**Responses to NRC Letter Dated August 19, 1997 and December 5, 1997, Regarding NRC
Acceptance Review of the Reclamation Plan for the White Mesa Uranium Mill**

**Source Material License SUA-1358
Docket No. 40-8681**

**Response to Nuclear Regulatory Commission / White Mesa Mill Reclamation Plan
Comments Dated August 19, 1997
Source Material License SUA-1358**

**Response to Nuclear Regulatory Commission / White Mesa Mill Reclamation Plan
Comments Received December 8, 1997
Source Material License SUA-1358**

FIGURE 2

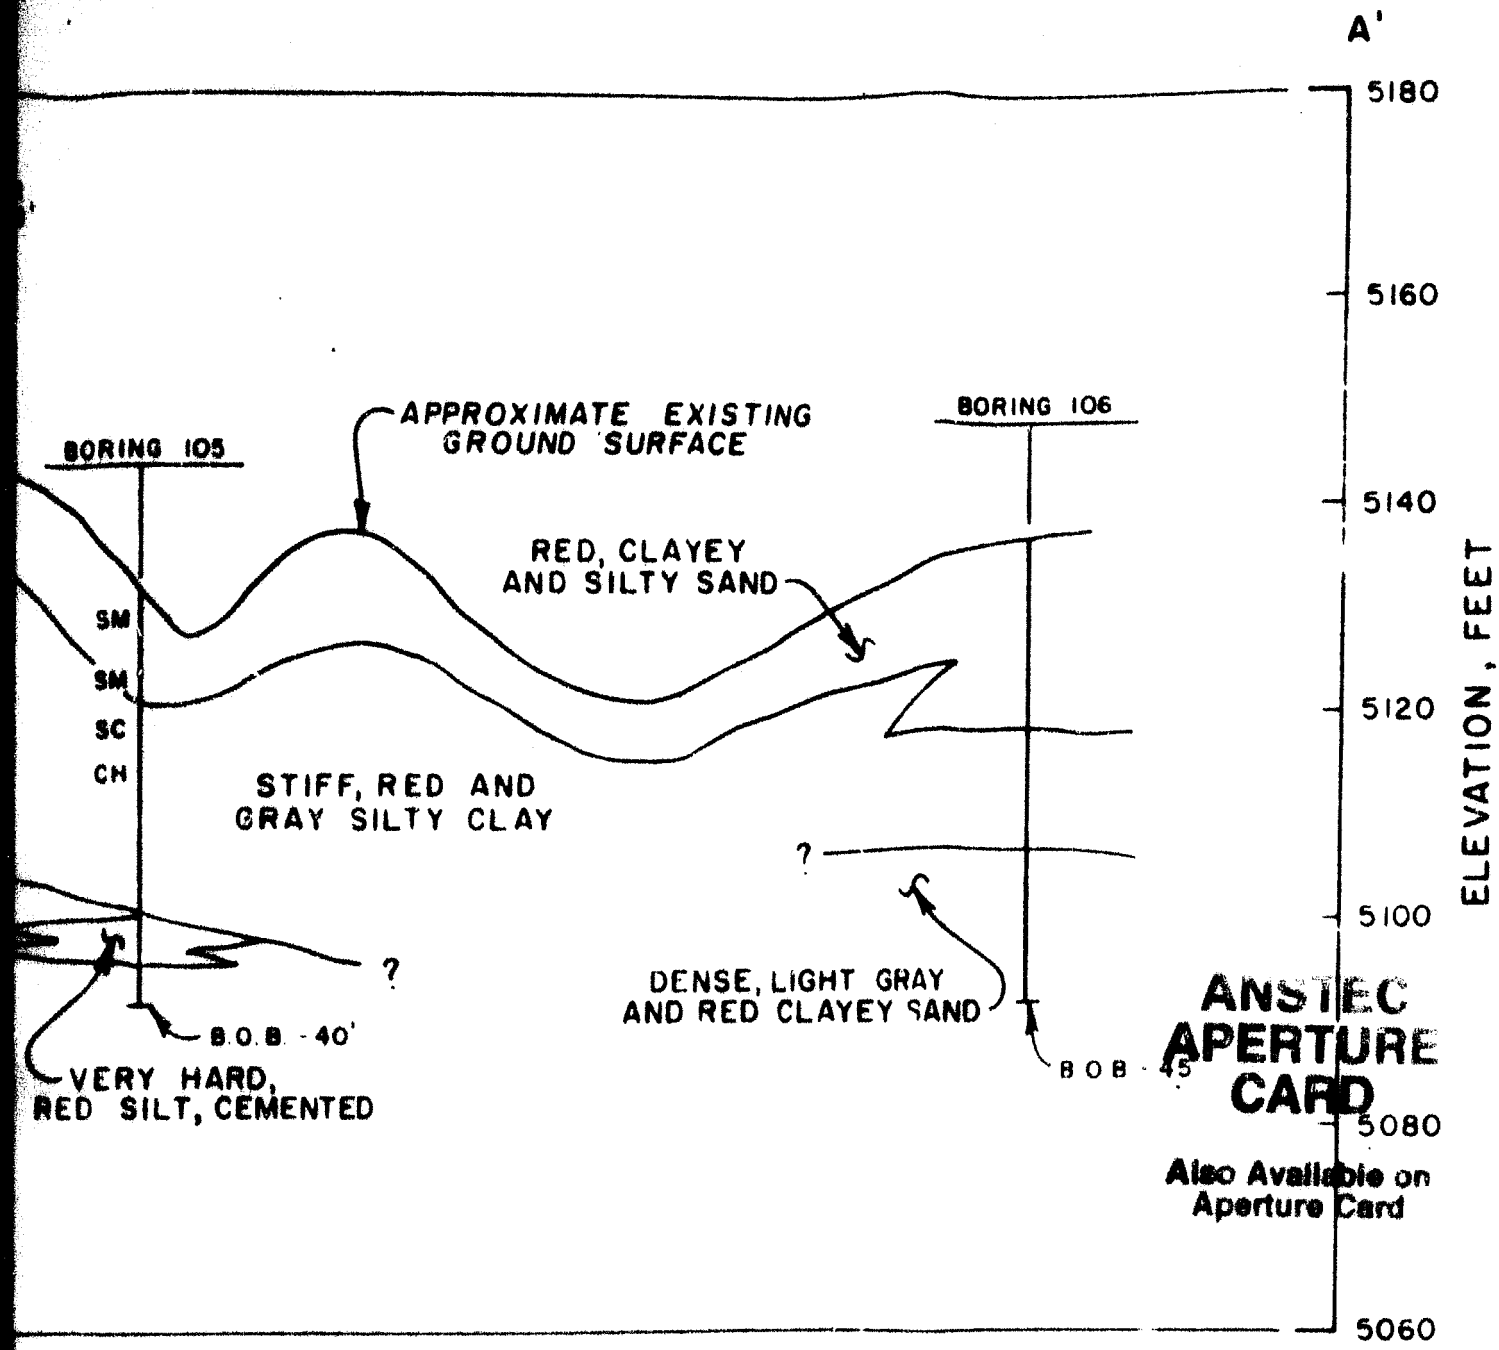
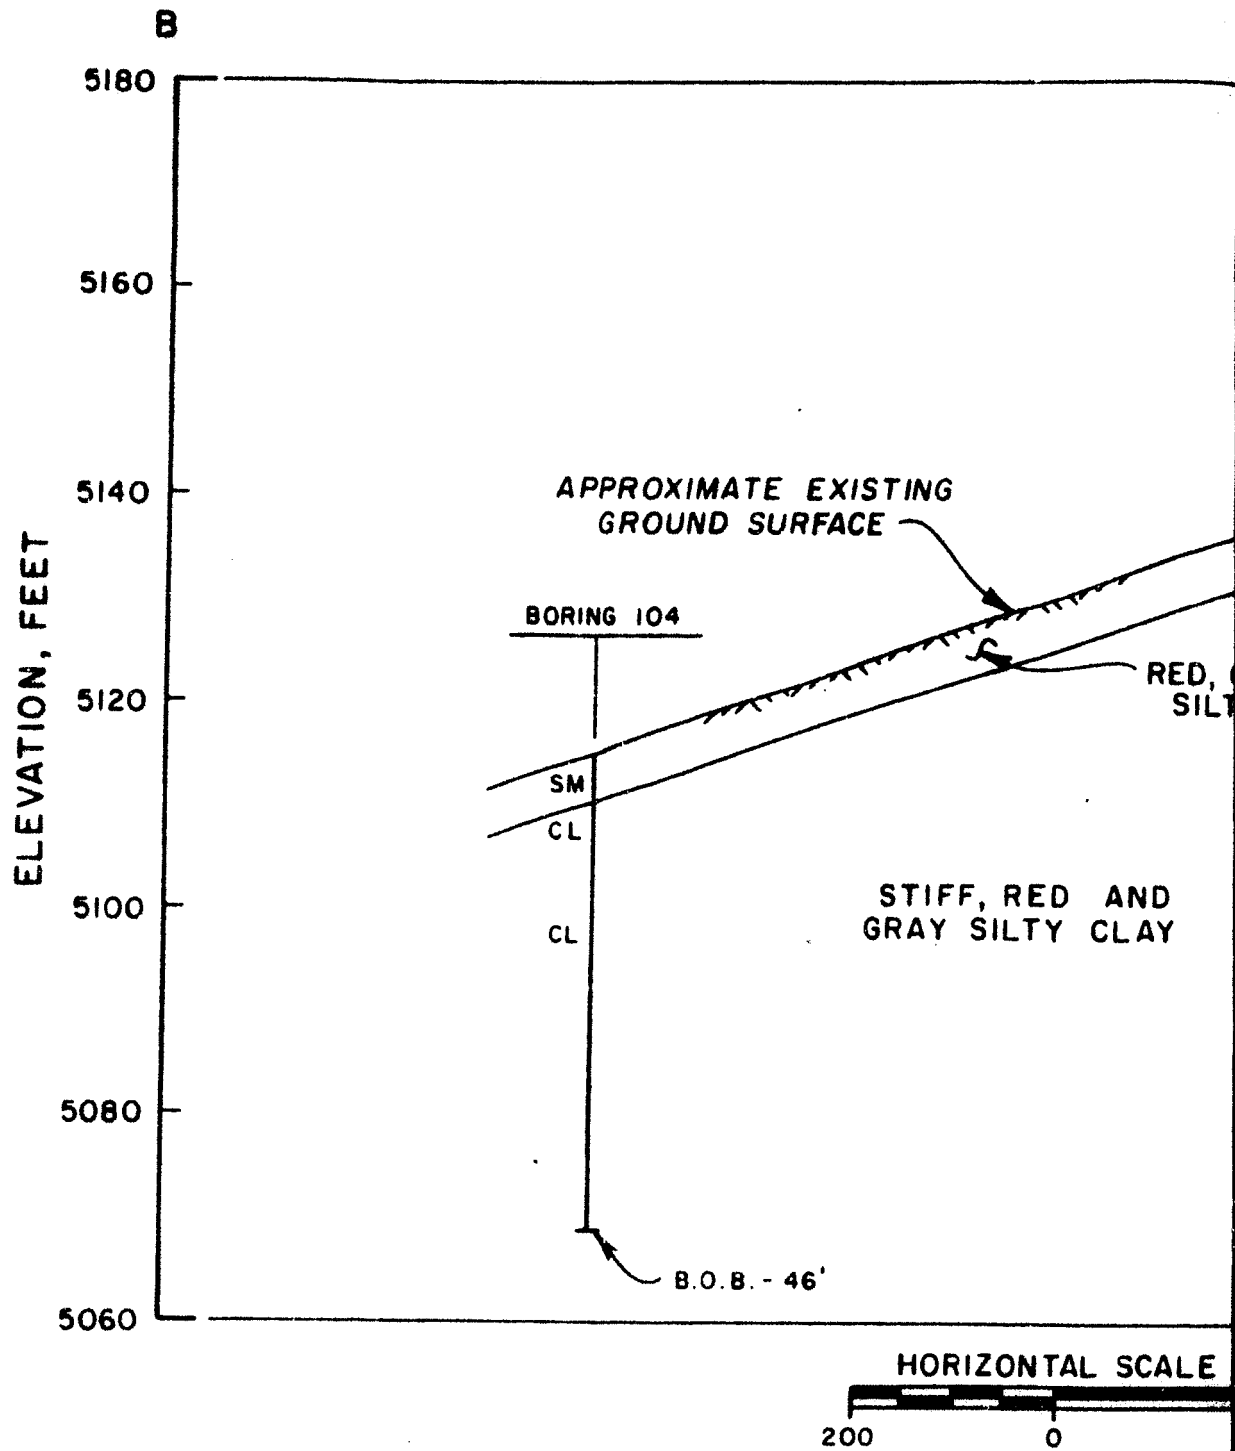
**(1) Information to support a review of the acceptability of the radon barrier design.
Specifically:**

The subsurface conditions in the canyon, based on the boring data, are shown on Cross Sections A-A' and B-B' presented on Figures 2 and 3, respectively. The plan locations of these cross sections is shown on Figure 1. As shown on the cross sections, the subsurface consists of a surficial layer of red clayey and silty sand about five feet thick. The underlying material is mostly a red or gray silty clay. The consistency of the silty clay layer varies from stiff to hard, based on observations of the drillers and rig during drilling. A lense or layer of very hard silt was noted in Boring 105. This layer appears to be a well cemented unit from the cutting samples obtained. In Boring 106, the surficial sand layer was about 20 feet thick and a clayey sand layer was also encountered at a depth of about 30 feet.

The laboratory soil classifications for the tested samples are also shown on Cross Sections A-A' and B-B'. The testing program is discussed in detail in the following section, however, the testing results indicate that the silty clay layer is mostly a CL or CH material with one sample being a SM and two a ML. These test results show the material is basically a fine grained soil with a varying amount of silt and clay size particles. The plasticity characteristics of the material vary from low to high. Further discussion of the test results and material characteristics is given below.
